**PUBLIC COMMENT REPORT
ADDENDUM**

**PUBLIC COMMENTS RECEIVED ON
FIRST PUBLIC REVIEW DRAFT**

**ICC/ANSI A117.1 STANDARD
DEVELOPMENT - 2014 EDITION**

ICC A117.1 Standard – Accessible and Usable Buildings and Facilities

6-46-12 PC4

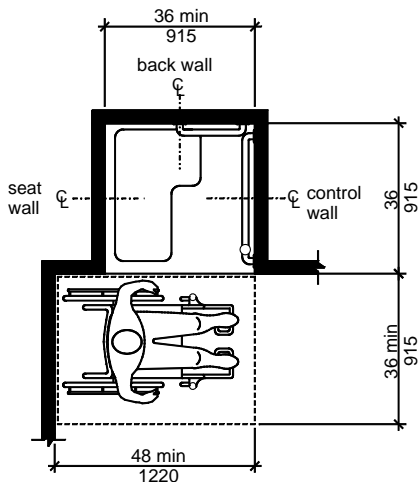
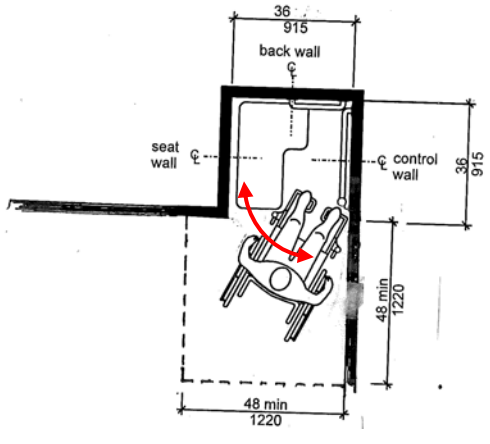
608.2.1.2 Clearance. A clearance of ~~48~~ 52 inches (~~1220~~ 1330 mm) minimum in length measured perpendicular from ~~12 inches (305 mm) beyond the seat~~ the control wall, and ~~36~~ 48 inches (~~915~~ 1220 mm) minimum in depth shall be provided adjacent to the open face of the compartment.

Reason: Delete this figure

The existing figure to accompany this provision should be modified because transfers for individuals who are non-weight bearing or non-ambulatory are not linear transfers. The figure implies a transfer position that is non-functional and impossible for non-weight bearing and non-ambulatory individuals to transfer from. This linear figure should not appear anywhere in the standard. Non-weight bearing and non-ambulatory wheelchair users will position the wheelchair anywhere from a 45 degree angle to a 90 degree angle from the shower seat. They will run the front of the wheelchair (feet) into the shower as far as possible and plant their feet and pivot in an arc to the shower seat. Additional floor space beyond the control wall is useless and unnecessary for this type of transfer. To accommodate the larger clear floor space of the wheelchair, additional depth of the clearance is required. This arc type transfer is similar for transferring to any object, water closet, bench, etc.

Note to Committee. *The figures submitted by Mr. Wiehle both include a red arrow indicating the directions of transfer to and from the shower seat. Unfortunately my technology is preventing the arrow in the first figure from appearing. It should be located vertically across the person's shoulders and to the midpoint of the seat. The second figure shows the arrow as supplied by Mr. Wiehle.*
